Exhibit No. ___ T (JBT-1CT)
Docket UE-152253
Witness: Jeremy B. Twitchell
REDACTED VERSION

DOCKET UE-152253

CONFIDENTIAL TESTIMONY OF

Selective Catalytic Reduction at Jim Bridger

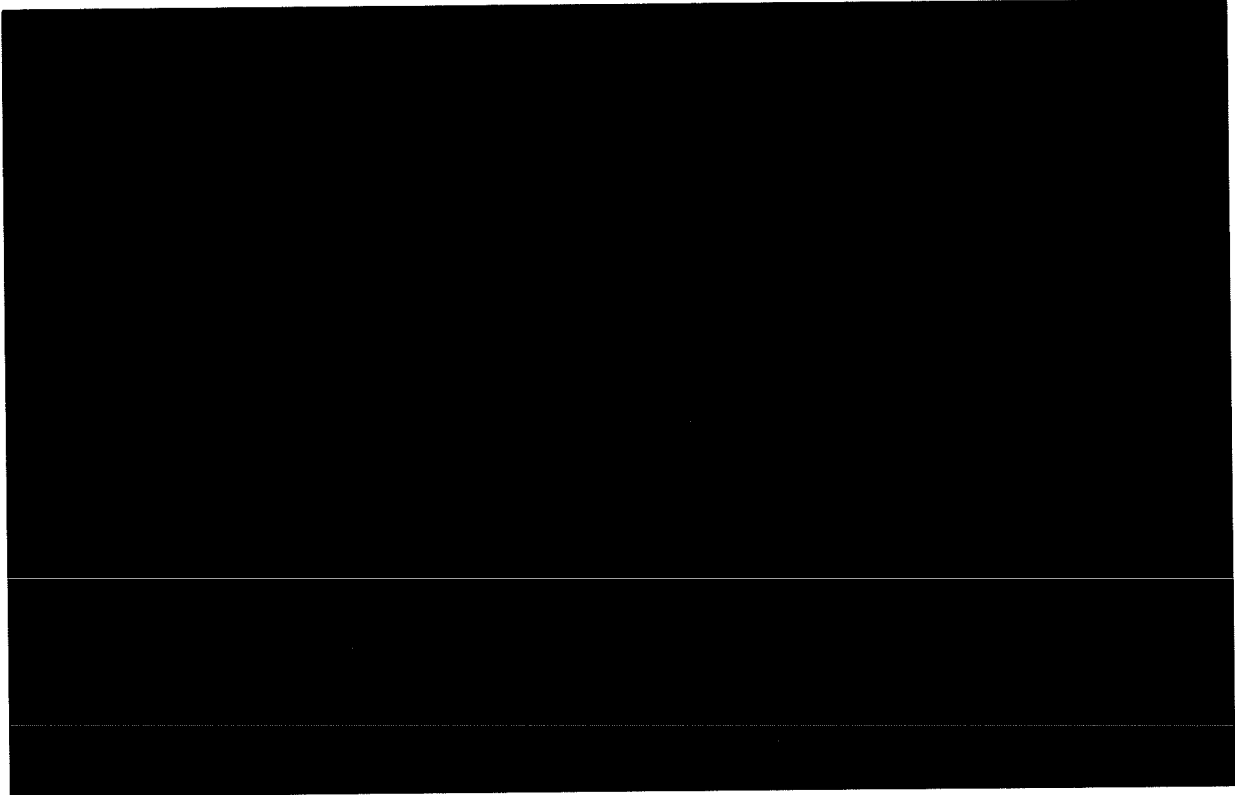
4
5
6 As the figure shows, the September 2013 OFPC (thick line) is at the top of
7 the range. Although it starts out in the middle of the pack in 2016, the September
8 2013 OFPC forecasts a steep, sustained increase that moves it to the top of the range
9 by 2021, where it remains for the rest of the period. Only two other curves end up in
10 the same range by 2030, but it is important to note that those two curves forecast a
11 gradual, stable increase from 2016 to 2030. The September 2013 OFPC, with its
12 aggressive assumptions in the early years of the forecast, effectively maximizes the
13 levelized price of natural gas, which makes the commodity appear significantly more
